SERVICE BULLETIN

SB1247

ADDRESSEES	: Owners and operators of coaches listed under 'Application'
VEHICLE MODEL	: TD925
SYSTEM/SUBSYSTEM	: Traction engine-Fuel system
BULLETIN TYPE	: Safety Recall NHTSA 12V-505
DATE	: November 27, 2012
SUBJECT	: Fuel Pro-filter compartment – To install thicker base plate
TERMS & CONDITIONS	: Refer to the warranty section further in this Bulletin.

Figure 1

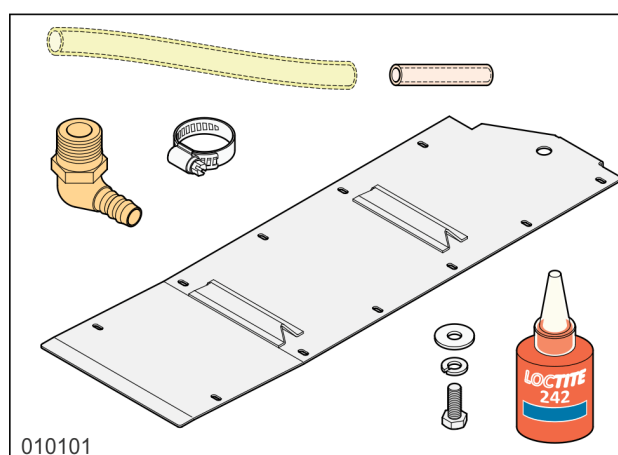
1. In the event of a tag axle left tire blow out, the debris might damage the Fuel Pro filter compartment base plate. If this base plate cannot withstand the impact from the debris, the drain valve and/or water-in-fuel sensor fitted at the bottom of the Fuel Pro filter might be damaged. With running engine, this damaged drain valve and/or water in fuel sensor allows fuel to leak and spread into the engine compartment, thus increasing the risk for a potential fire hazard.
2. On the recalled vehicles it is necessary to fit a thicker stainless steel base plate. This plate will provide sufficient protection to the Fuel Pro filter should any tire blow out occur. For this purpose, thicker plates have been made available. Refer to the procedure in this Service bulletin for fitting instructions. The terms and conditions of the campaign have been detailed in the warranty section.

VH reference	Description	Qty.
11247681	Fuel Pro filter compartment base plate - 3 mm thick	1
90854A135	Cap screw M6 x 20 Class 10.9 Zinc Steel	13
660623501	Washer M6	13
660636302	Lock washer M6	13
91458A111	Loctite 242 locking compound, .02 oz, Blue	1
53525K57	Brass 90 Deg Barbed Elbow for 3/8" Hose ID x 1/2" NPTF Male Pipe	1
5552K27	Fuel Yellow Tygon PVC Tubing 3/8" ID, 1/2" OD	2
5388K14	Hose Clamp 7/32" to 5/8" Range, 5/16" Band Width	3
53945K31	Rigid Clear PVC Tubing, 1/4" ID x 3/8" OD x 1/16" Wall Thickness	2

Figure 2

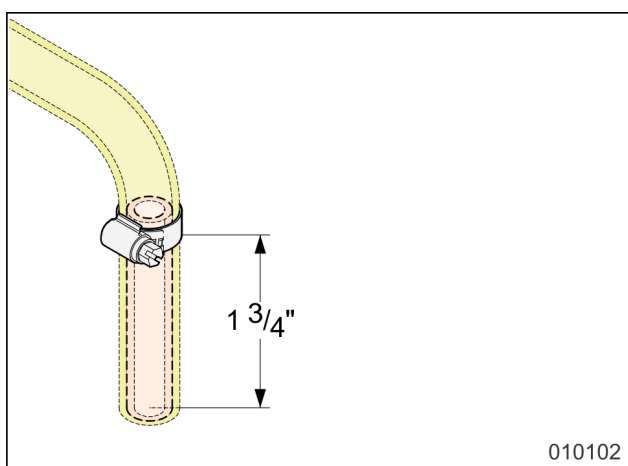
- 1) Remove and discard the existing base plate, bolts and washers.
- 2) Remove and discard the existing drain hose and barbed fitting from the bottom of the Fuel Pro filter drain valve.
- 3) Install the 90 Deg barbed elbow onto the bottom of the Fuel Pro filter drain valve. Point the barbed section towards the engine.
- 4) Install the yellow fuel hose onto the barbed elbow and secure with a clamp.
- 5) Fully insert the two inch of rigid PVC tubing into the free end of the yellow fuel hose.
- 6) Install a clamp over the free end of the yellow fuel hose and secure it 1 $\frac{3}{4}$ " away from the end (Figure 2).

Figure 3

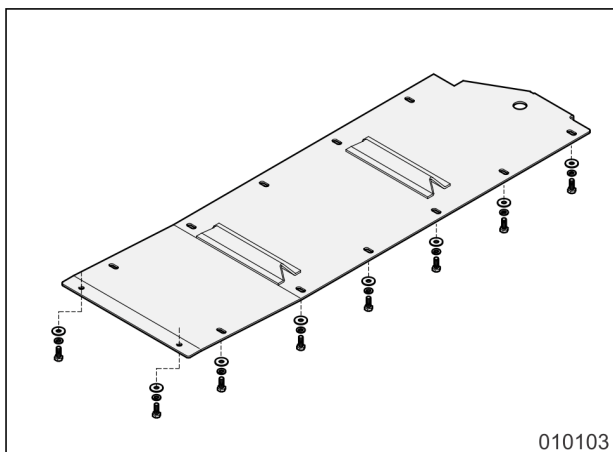
- 7) Install the new 3 mm thick base plate using M6 x 20 Class 10.9 cap screws, M6 lock washers, and M6 washers (Figure 3).

NOTE: The two outboard screw holes must be match drilled in the plate. Coat the screw threads with Loctite 242 and tighten to a torque of 100 in-lbs. If any of the nutsert threads are stripped, drill it out and install the screw with a suitable nut and washer on the top side.
